MEMO

RE: Change Order

The following change order is being recommended for the Gateway/Breathitt project to fully utilize our grant funds.

PROJECT: (Name and address) Gateway Academy - Breathitt Center 705 N Elm Street Hopkinsville, KY 42240

FROST FREE OUTSIDE HYDRANT ADDITION

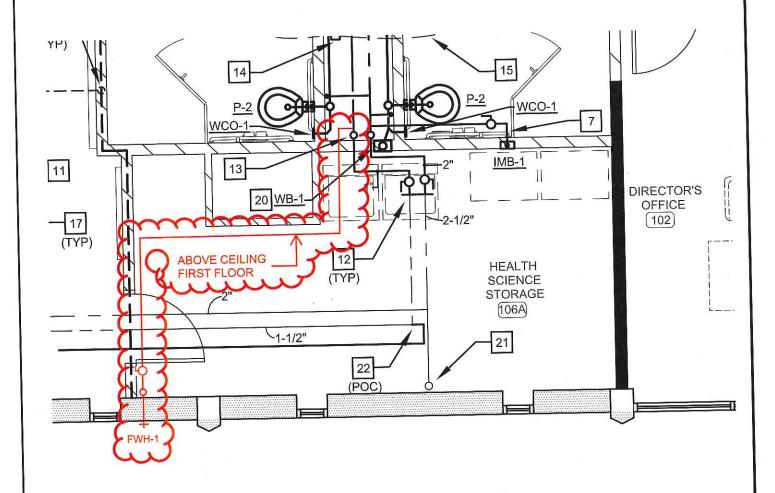
Owner requested pricing on the addition of an outside frost-free wall hydrant.

The Contractor shall provide a proposal for all labor and materials to install a frost-free wall hydrant to include piping, hangers, insulation as shown on Sketch XP01. Installation shall be in accordance with the Contract Documents and all applicable codes.

PROPOSAL REQUEST NO. 1 - PARTIAL REVISED FIRST FLOOR NEW WORK PLAN SHEET NO. PR1.1 JOB NO. SHERMAN CARTER BARNHART GATEWAY ACADEMY AND **COPYRIGHT © 2019** 01/04/19 DATE **BREATHITT CENTER PROJECT NAME** SHERMAN CARTER BARNHART RENOVATION ARCHITECTS, PLLC MM DRAWN HOPKINSVILLE, KY PROJECT LOCATION

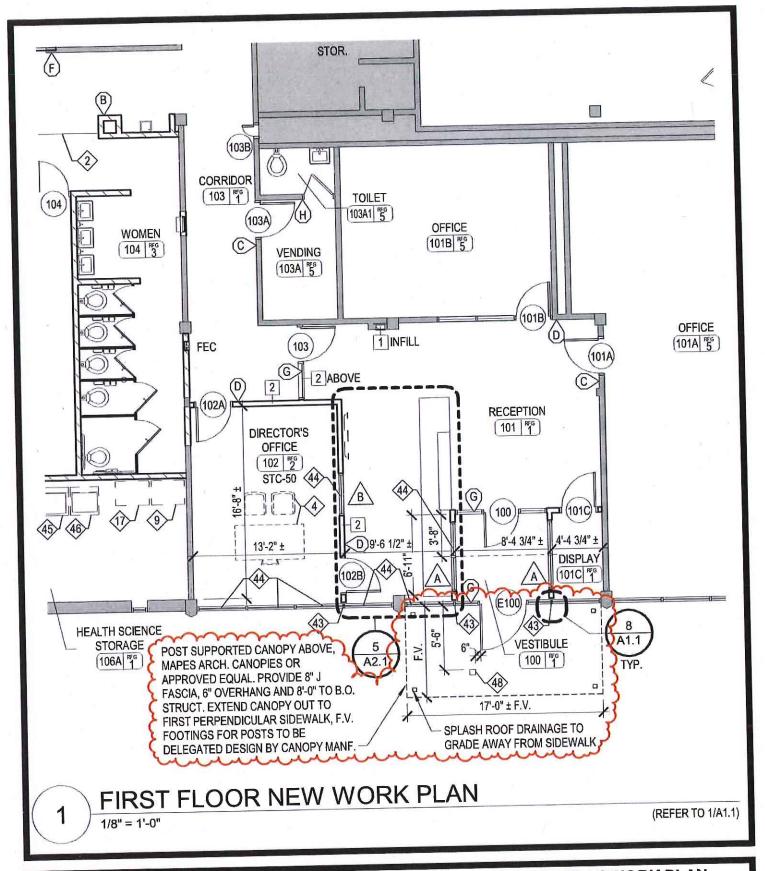
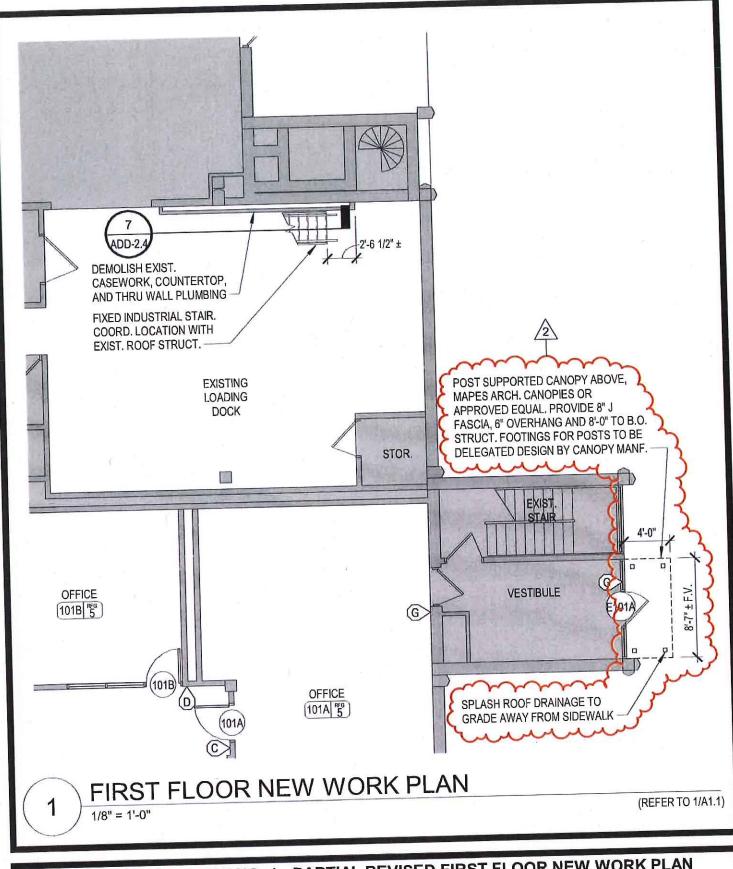
Provide new Mapes Arch. Canopies or approved equal per the attached revised floor plans. Coordinate canopy posts, foundations and drainage with existing sidewalks.

PROPOSAL REQUEST 3 - DEMOLITION AND NEW WORK PLANS SHEET NO. PR3.1 1808 JOB NO. **GATEWAY ACADEMY AND COPYRIGHT © 2018** DATE 03/06/19 **BREATHITT CENTER PROJECT NAME** SHERMAN CARTER BARNHART RENOVATION **ARCHITECTS, PLLC** AHO DRAWN HOPKINSVILLE, KY **PROJECT LOCATION**

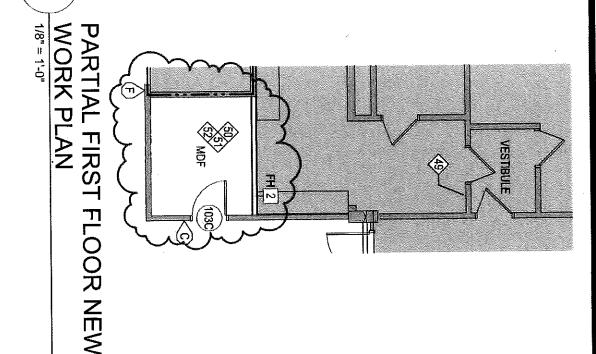
Demolish existing casework and accessories in new MDF. Modify existing lighting and ductwork as required. Construct new wall, furnish and install new lighting, mini-split and all related accessories. Paint all walls and modify existing flooring as required.

21. DEMOLISH EXIST. WD. CASEWORK, FIXTURES, WALL PANELS AND ACCESSORIES TO NEAREST JOINT AS REQUIRE FOR NEW WORK. PATCH AND PREP SURFACES FOR NEW FINISHES. PAINT WALLS WHERE CASEWORK IS REMOVED FOR CONSISTENT FINISH.

49. MODIFY EXISTING FLUORESCENT LIGHTING TO EXTENTS REQUIRED FOR NEW WORK, PROVIDE NEW SWITCH AT THIS LOCATION.

50. FURNISH AND INSTALL TWO (2) NEW SUSPENDED LED LIGHTING FIXTURES TYPE 'E' WITH DIMMER SWITCH. REFER TO ELECTRICAL LIGHTING FIXTURE SCHEDULE. COORDINATE LOCATION WITH OWNER'S PREFERENCE.

51. FURNISH AND INSTALL TWO (2) NEW DUPLEX OUTLETS ON SINGLE 20-AMP CIRCUIT. LOCATE PER OWNER'S PREFERENCE.

52. FURNISH AND INSTALL NEW MINI-SPLIT HVAC UNIT. COORDINATE LOCATION WITH OWNER'S PREFERENCE. PROVIDE AND INTEGRATE THERMOSTAT INTO BUILDING CONTROL SYSTEMS.
